EA02-025
TEXAS INSTRUMENTS, INC.'S

ENGINEERING CHANGE NOTICE

PROD. AREA: VALVES	SUBJECT: FM-10 PRESSURE SWITCH	PROGRAM: DUAL PROP	MODEL YEAR: 93	CUSTOMER(S): FORD	ECN NO.: 25136 PAGE 1 OF 1			
NATURE OF CHANGE: REVISE THE T.I. PRESSURE SWITCH - NEW AUTOMATED VERSION IS AVAILABLE. NOTE: THIS IS A CHANGE TO CUSTOMER DRAWING.				EPA NO.: 48011-B REF. DOCUMENTS: CUST. CHG.: K-H DEV. / MCR: K-H EST.: K-H NTR.: ATTACHMENTS: DISTRIBUTION CODE:	CLASSIFICATION: REGULAR ☒ RECORD MANDATORY EXPEDITED			
REASON: CUSTOMER REQUEST: ☒ PLANT REQUEST: ☐ VENDOR/PURCHASING REQUEST: ☐ T.I. NOW HAS TIKER AUTOMATED ASSY GOING. - NEED TO UPDATE PRINTS SO ISIR WILL REFLECT PRODUCTION LEVEL SWITCH. AS THEY WILL BE PERFORMED ON ENTIRE VALVE FOR ISIR TO FORD.				VEHICLE APPLICATION: PASSENGER ☒ TRUCK TRAILER SERVICE				
IS TEST REQUIRED: YES ☒ NO ☐ CONCURRENT ☐ TEST DURATION, DAYS: 30				INITIATED BY: J. COSSINS B-2 DATE: 9-5-91				
APPROVED BY:								
PRODUCT ENGINEERING		DATE	DATE		DATE

REVISED & REDRAWN		
910417	NCODE10079779005	10
DATE	REL. NO.	CR.
NAME SWITCH ASY - SPEED CONTROL DEACTIVATE		
NO. ▽F2VC-9F924-AB

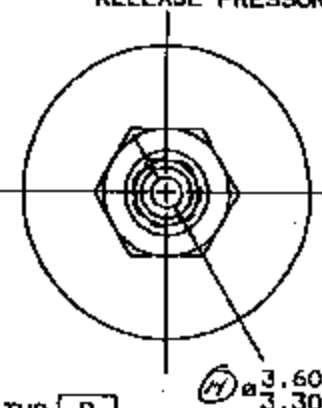
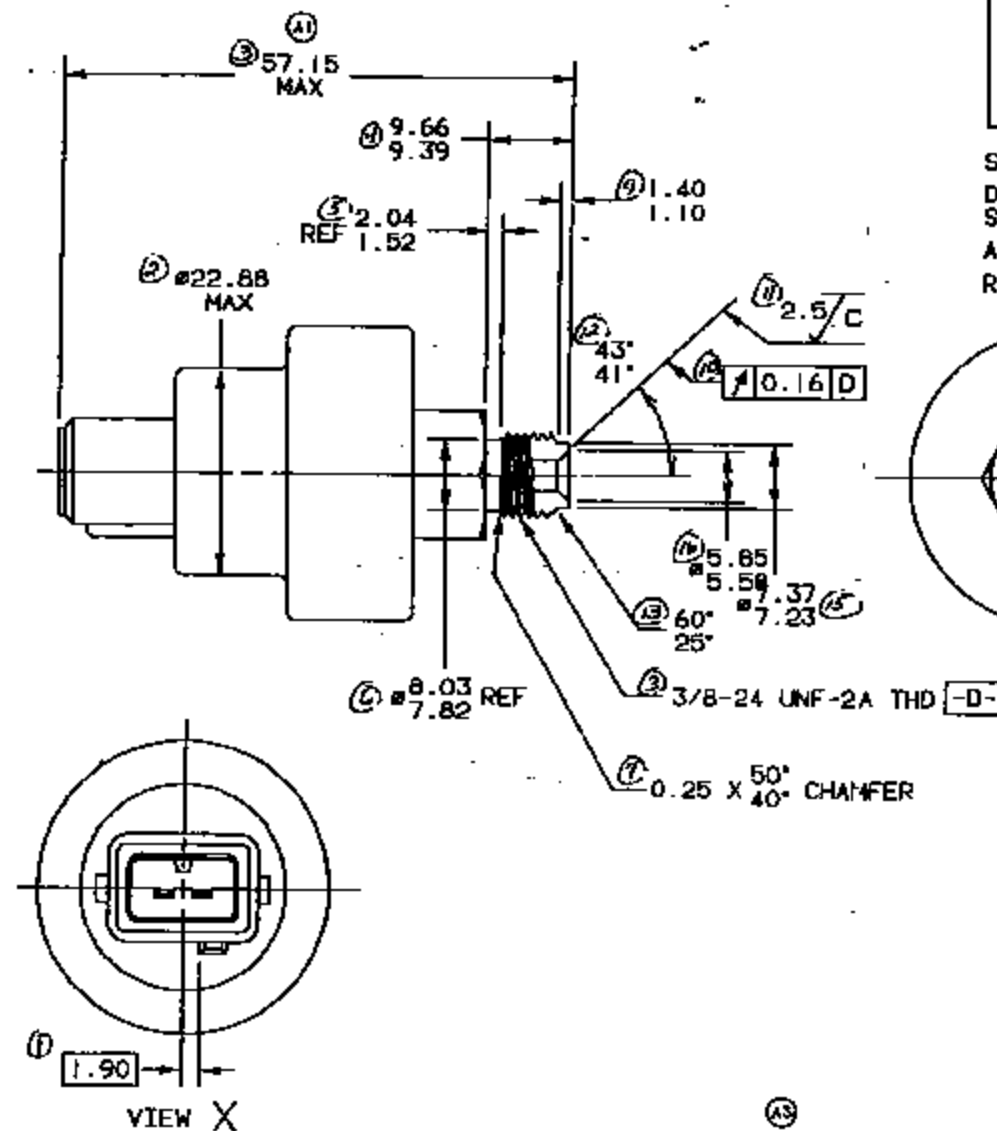
D-12590701	A5	ASSY - PRESSURE SWITCH	1	X	NO STK
					- REVISE TO T.I. PRINT 77PSL2-1 WAS TO 57PSL5-3.			
					NOTE THE ONLY VISIBLE CHANGE IS THE OVERALL LENGTH ON SWITCH. SO SPECIFIC CHANGES ARE:

1) CHANGE TO "57.15" MAX" WAS "62.23" MAX			
					2) CHANGE TO "P2VC-9F924-AA" WAS "P2VC-9F924-BA"			
					3) CHANGE T.I. P/N TO "77PSL2-1" WAS "57PSL5-3"

4) REMOVE "FOR FINAL ASSY SEE DWG. 12575501"			
			D-12603101	B	ASSY 'S - FN-10 DUAL PROP	1		NO STK
			D-12603101	B	- REFLECT ABOVE CHARGES ON THESE DRAWINGS AND PARTS			
			D-12603401	B	LIST			
			P-12603401	B				
			P-12607101	B				
APPROVED								
PLANT(S) INVOLVED: AUG 20 1991						ECN NO.: 25136

A5	ADDED CONTROL ITEM BLOCK	9-5-91	CS	JT
		A4	REMOVED THE FINAL ASSY REL...	9-5-91	CS	JT
		A3	MAX STRENGTH-3	9-5-91	CS	JT
		A2	MAX F2VC-9F924-AA	9-5-91	CS	JT
8438	25136	A1	MAX 42-23 MAX DIM	9-5-91	CS	JT
8438	301		RELEASED	1-11-91		
EPA/MTR	DRG/ECN	Q66	REVISION	DATE	DR.	CK.
UNLESS OTHERWISE SPECIFIED.			MATERIAL/FINISH			
PART TOLERANCES						
S	ONE PLACE DECIMAL					
S	TWO PLACE DECIMAL					
S	CASTING					
S	MILLING					
SEE DIM. INTERPRETATION SPEC. P. 8. 843808						
SCALE 2 X SIZE			3RD ANGLE PROJECTION			
DO NOT SCALE DIMS						
PART DESCRIPTION						
METRIC			ASSY-PRESSURE SWITCH

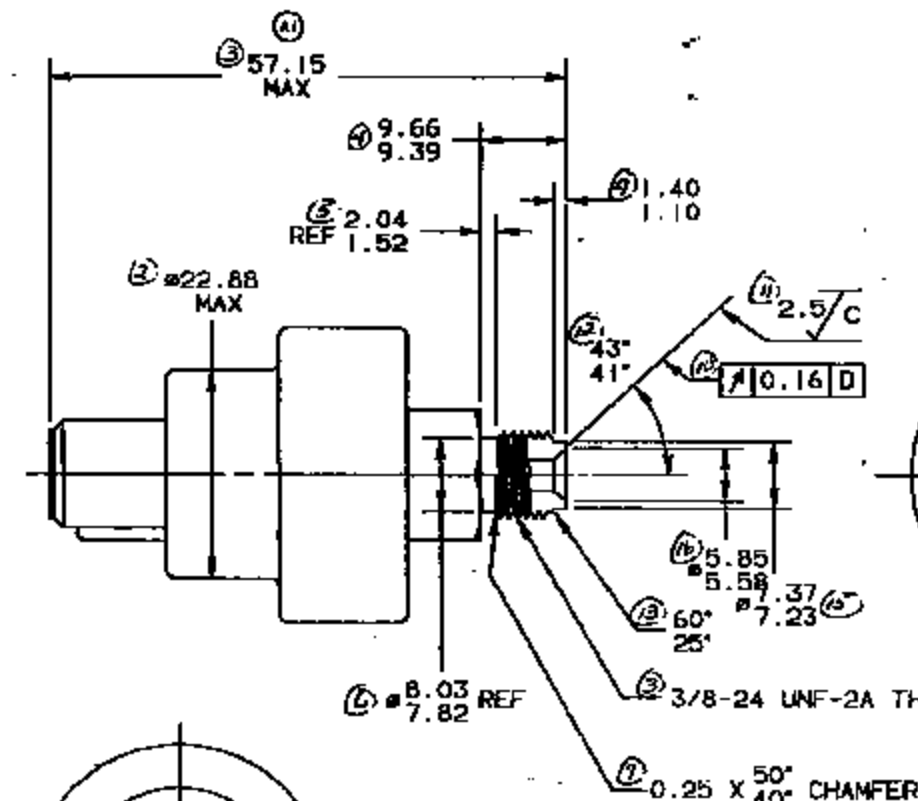
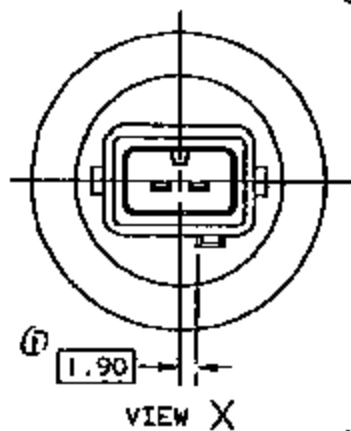
- REVISE TO T.I. PRINT 77PSL2-1 WAS TO 57PSL5-3.					
NOTE THE ONLY VISIBLE CHANGE IS THE OVERALL DIM WITH					
ON SWITCH. SO SPECIFIC CHANGES ARE:					
1) CHANGE TO "57.15 MAX" WAS "62.23 MAX"

2) CHANGE TO "P2VC-9F924-AA" WAS "P2VC-9F924-BA"					
3) CHANGE T.I. W/N TO "77PSL2-1" WAS "57PSL5-3"					
4) REMOVE "FOR FINAL ASSY SEE DWG. 12575501"					
ASSY'S - FN-10 DUAL PROP 1 NO STK

A5	ADDED CONTROL ITEM BLOCK	9-5-91	CS	JT
		A4	DESIGNED "FOR FINAL MNT USE..."	9-5-91	CS	JT
		A3	WAS STPPLS-3	9-5-91	CS	JT
		A2	WAS F2VC-9F924-AA	9-5-91	CS	JT
B43B	2513B	A1	WAS 82.23 MAX DIM	9-5-91	CS	JT
B43B	301		RELEASED	1-11-91		
EP/WR	DR/EDN	CHD	REVISION	DATE	DR.	CK.
UNLESS OTHERWISE SPECIFIED:			MATERIAL/FINISH			
PART TOLERANCES						
C			ONE PLACE DECIMAL			
E			TWO PLACE DECIMAL			
F			CASTING			
H			REGULAR			
SEE DIM. INTERPOLATION SPEC. P. 8 - 000000			 3RD ANGLE PROJECTION			
SCALE 2 X SIZE						
REPLACE PART						
PART DESCRIPTION						
METRIC						
			ASSY-PRESSURE SWITCH			
OR R. KENNEDY		DATE 12-15-90	 CADD DRAWING IS ELECTRONIC NO MANUAL CHANGE			
OR D. MURPHY		DATE 1-3-91				
CLUT						
APPROVED BY	DATE	SIGNATURE	REVISION			DWG. REV. LEVEL
ENG J. CALMS	1-11-91	C				
MAY						
RFB J. CALMS	1-11-91					
DES MGR E.A. WILLE	1-11-91					
			PART NUMBER			
			BASE NUMBER SUFFIX CHANGE LEVEL			
			D-12590701-A
